# TC1775

## 32-Bit Single-Chip Microcontroller

## TC1775 Documentation Addendum

**Revision History:**            **2002-07**

**DMU\_CON**

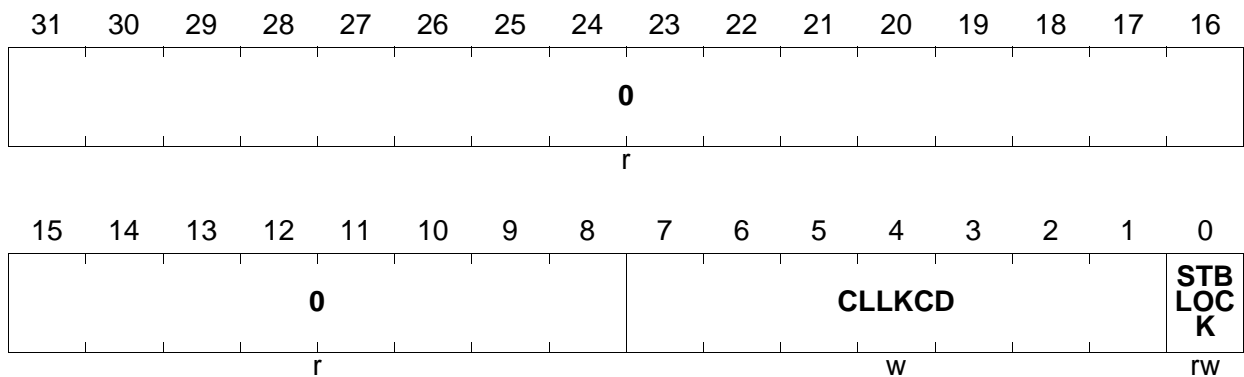
Page 9-11

The description of register DMU\_CON must be corrected in the following way:

Field	Bits	Type	Description
STBLOCK <sup>1)</sup>	0	rw	<b>Lock Standby Data Memory</b> Bit can be set by writing a 1 to it (in supervisor mode only). Bit can only be reset (in supervisor mode only) by writing a 0 to it together with the appropriate clear lock code. 0 Normal operation of standby data memory 1 Standby data memory is locked. No read or write access of/to standby SRAM is possible. The state of STBLOCK after power-on reset is undefined. A hardware or software reset does not effect this bit.
CLLKCD	[7:1]	w	<b>Clear Lock Code</b> This bit field has to be written with 65 <sub>H</sub> together with STBLOCK = 0 to reset the lock of the standby RAM.
0	[31:8]	r	<b>Reserved</b> ; read as 0; should be written with 0.

<sup>1)</sup> This bit field is not available in the TC1775 BA11 step.

**Figure 10-2 Example Configuration of a Data Protection Register Set**

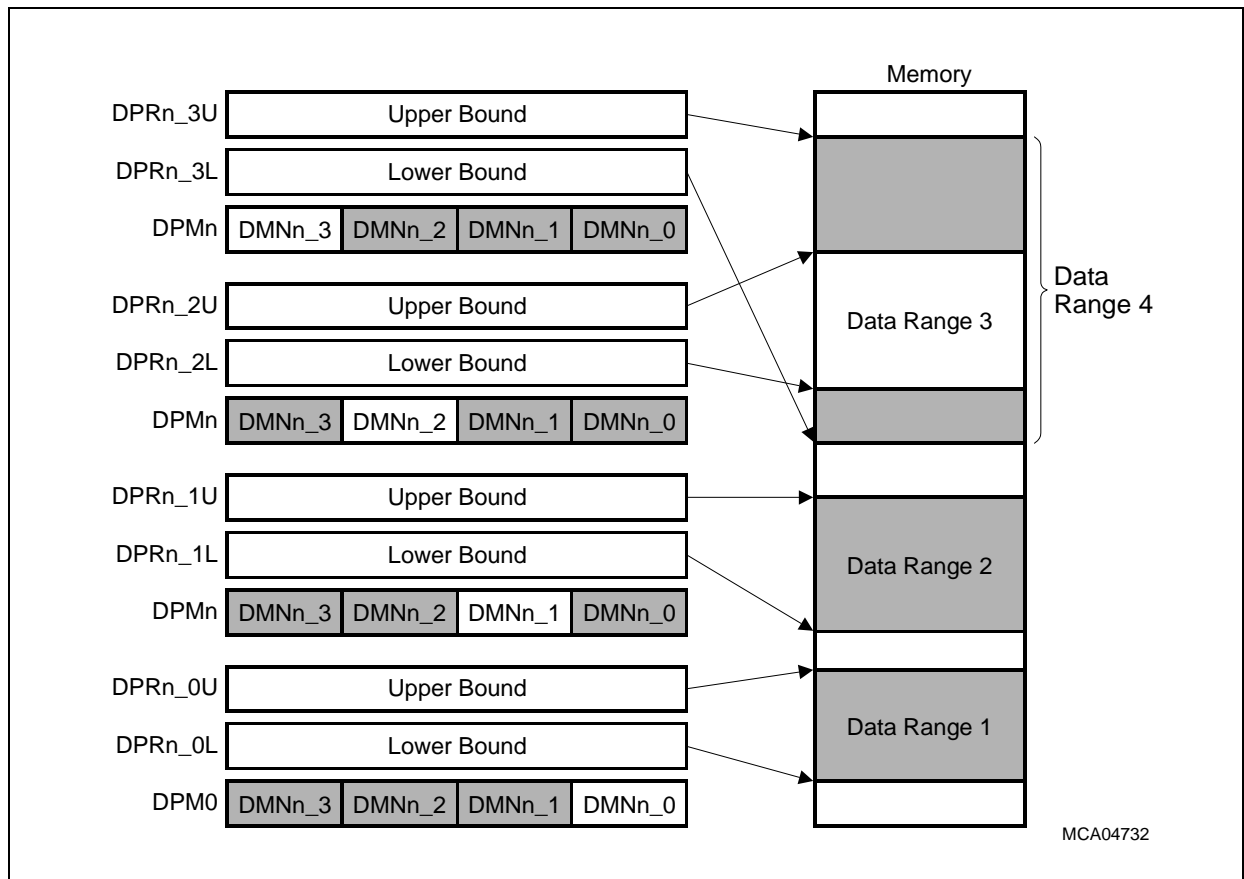
The Data Range numbering in **Figure 10-2** is not correct. The figure must be updated in the following way:

Figure 12-6 Basic Read Access Timing in Demultiplexed Mode

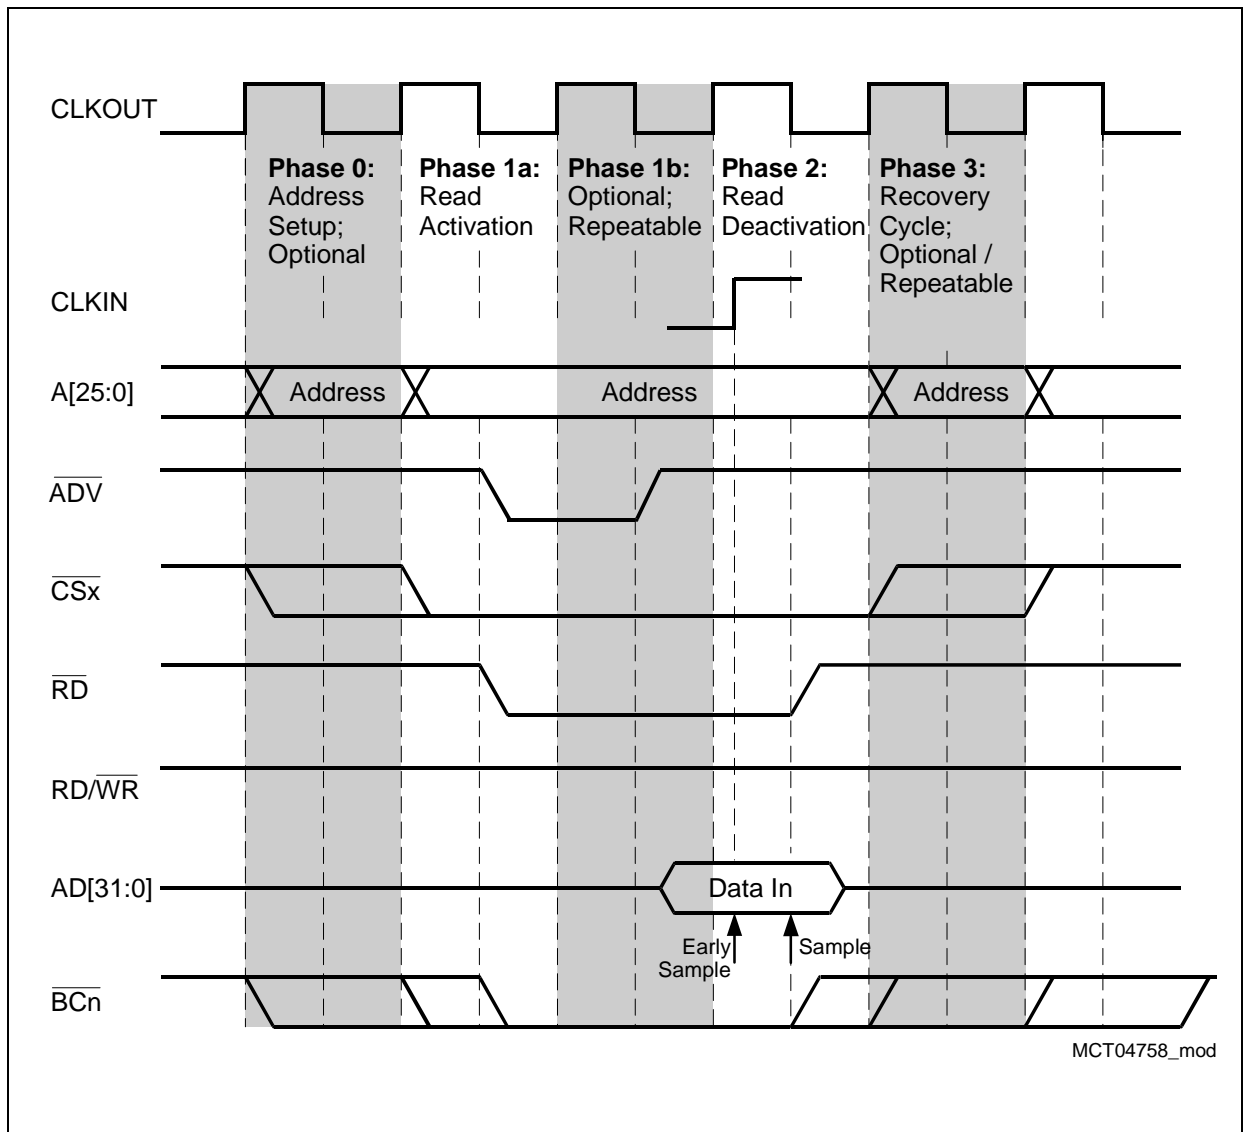
**Page 12-21, 12-22 (Figure 12-6), and 12-62**

The TC1775 provides an additional demultiplexed read timing feature called “Early Sample”. This feature is shown in the corrected **Figure 12-6** and controlled via bit 26 (called ES for “Early Read Sample Select”) in register EBU\_BUSCONx. EBU\_BUSCONx.ES must be added as described on **Page 10**).

Due to this new feature, the paragraph starting with “Phase 2: ...” on page 12-21 must be replaced by the following description:

- “Phase 2: This cycle is always part of a read access. Please note that the read signal is deactivated (high) on the falling edge of CLKOUT. The data input is sampled and latched with this clock edge ( $EBU\_BUSCONx.ES = 0$ ) or with the rising edge of CLKIN when early sample is enabled with  $EBU\_BUSCONx.ES = 1$ .”

**Figure 12-16 EBU Boot Process after Reset**

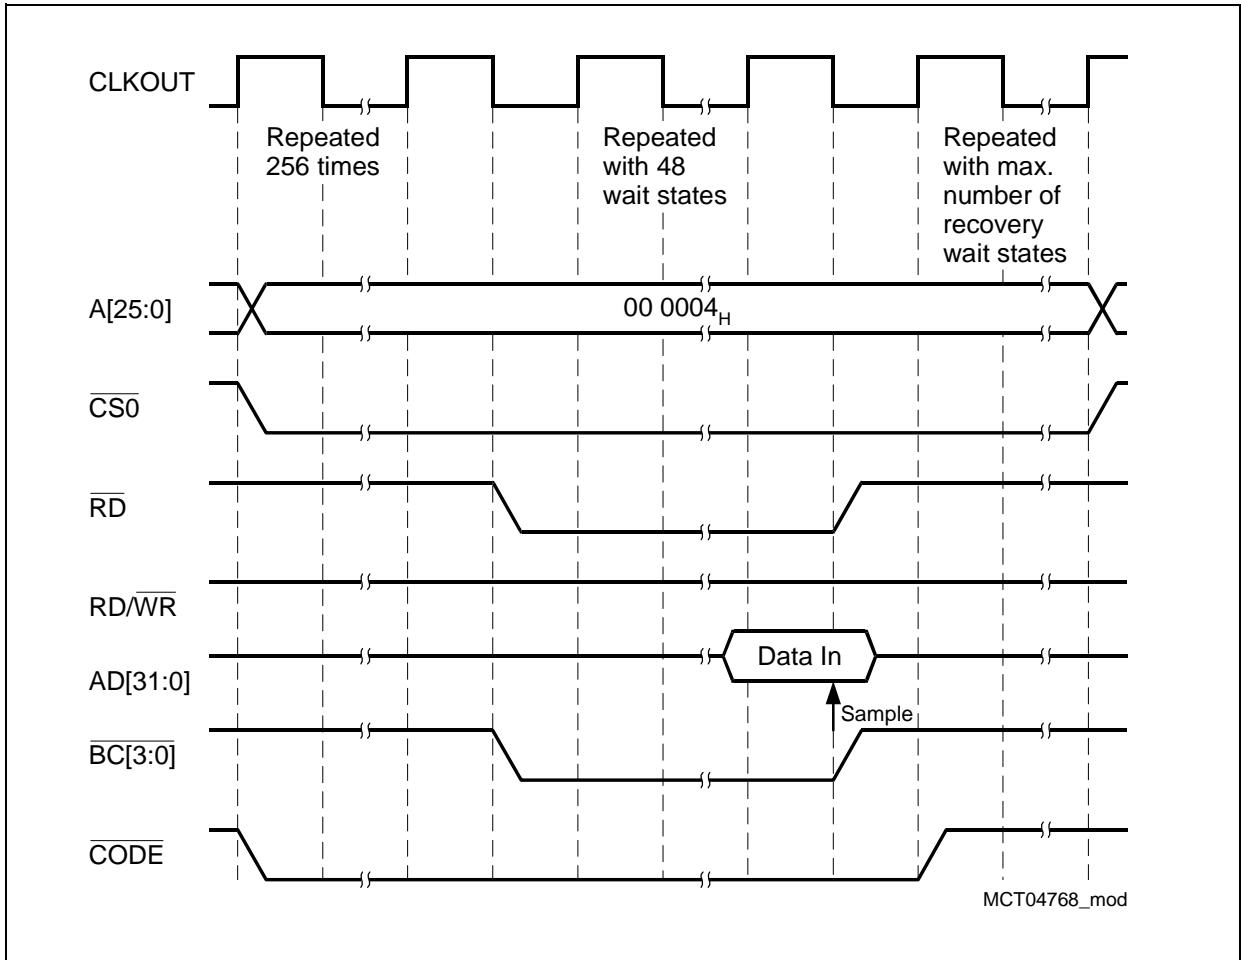
**Page 12-44, Update of Figure 12-16**

Figure 12-16 should be update with the following drawing:
